Service Letter SL 33-A	DO - No. EASA.21J.020
--	-----------------------------------	--------------------------

MTV-25-2-D-C-R(M)/CR170-23
Shrouded Propeller Installation

Not enough clearance between blade tip and shroud

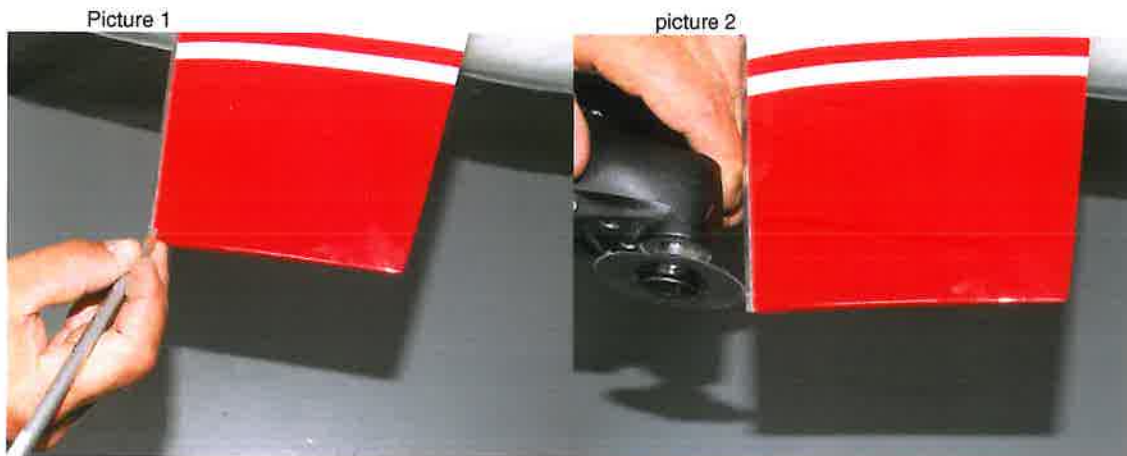
- Mark the blade tip exactly at the desired blade length and needed gap by appropriate means (picture 1)
- Cut the blade with a vibration saw (picture 2)

- **Start cutting from the leading edge to avoid stainless steel bonding delamination from the blade.**
- Smooth edges with sandpaper 220 grid
- To avoid moisture it is mandatory to cover the blade tips with 5 min epoxy
- Final painting is only for visual effect, not mandatory
- The min. allowable diameter is 165 cm according to Service Bulletin 1().
